TABLE 1 DESIGN EXERCISE – CONCEPT A

TABLE 1 DESIGN EXERCISE – CONCEPT B

TABLE 4 DESIGN EXERCISE – CONCEPT A

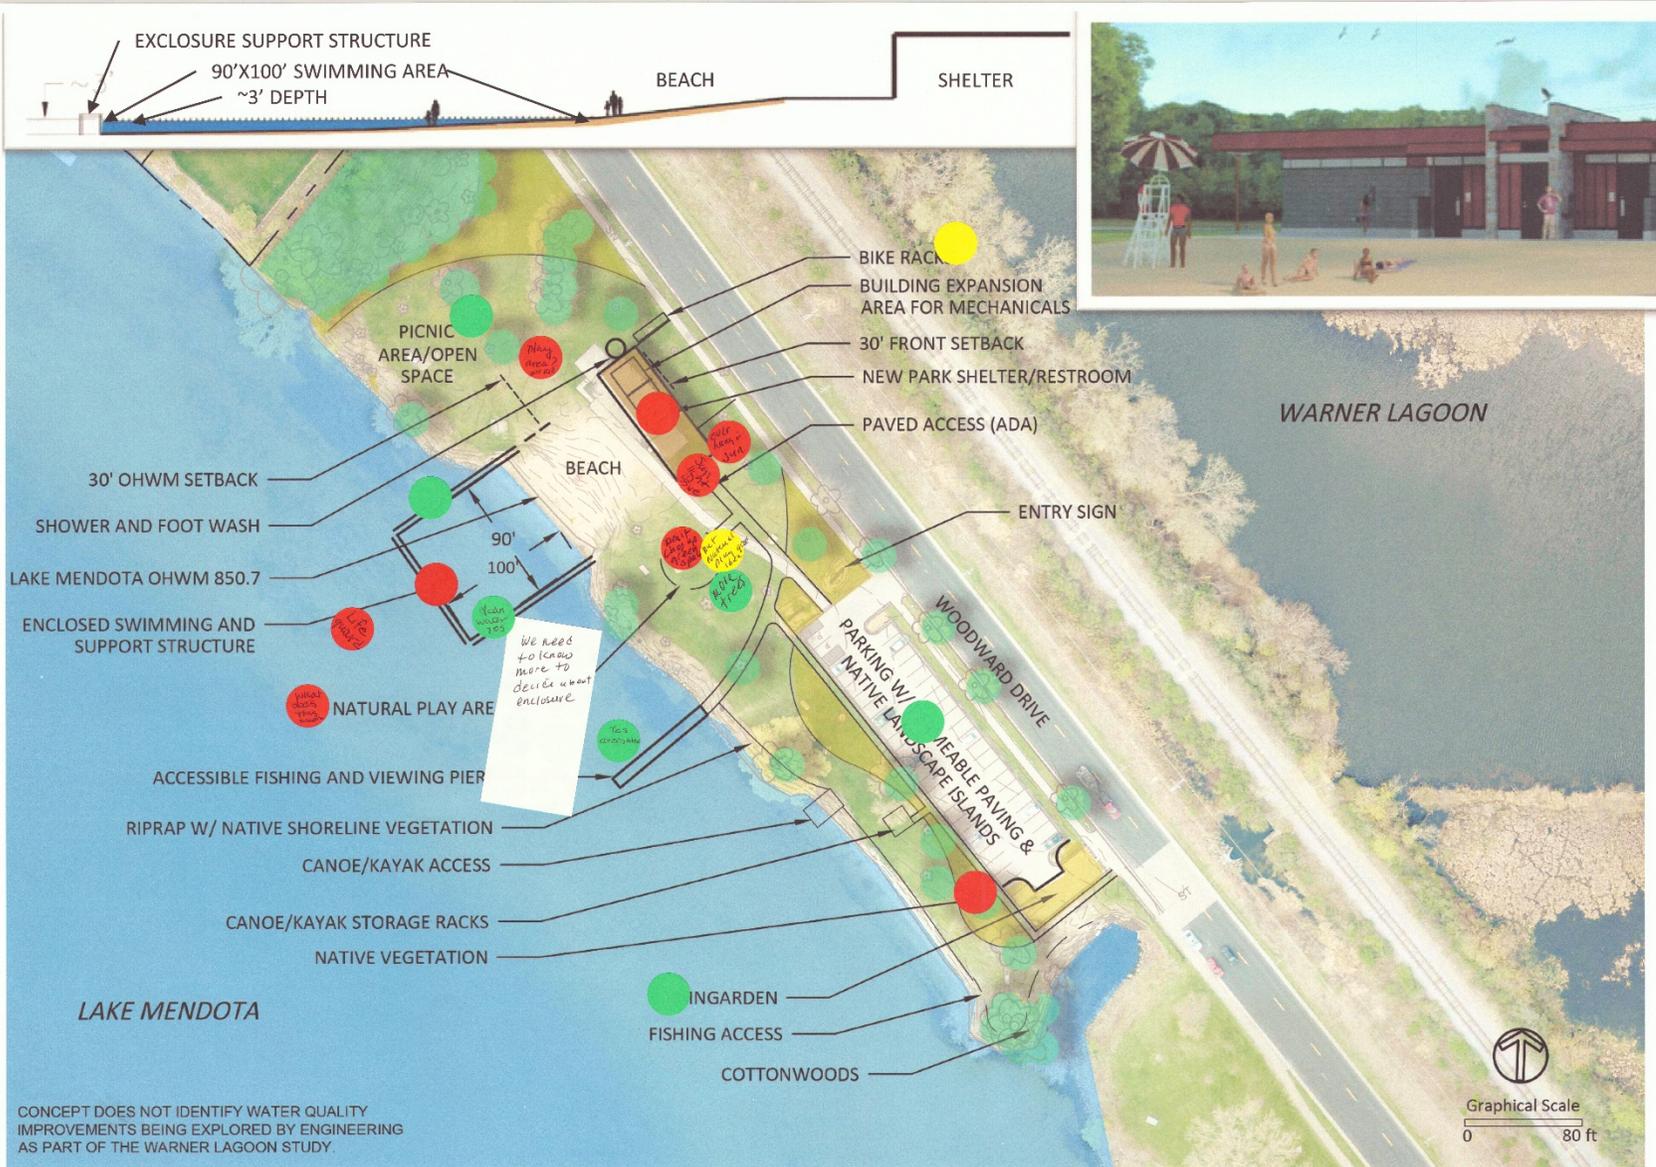
- Preferred park shelter in this concept to be mirrored. Want the overhang seating area closer to the beach and play area.
- Would like shower and footwash to be next to pavement along path as opposed to near sand.
- Would like sidewalk connection from Woodward to shelter.
- Would like cut out for bike path and connection to bike racks so that bikers don't have to go through parking lot.
- Bike racks should be near shelter.
- Question on natural play area.
- Place the canoe racks closer to the road or in parking lot so they are not an eyesore along the shoreline.
- Want more canoe and kayak racks closer to road.
- Questions on cost of enclosed swimming area vs. cleaning lake/beach more often.
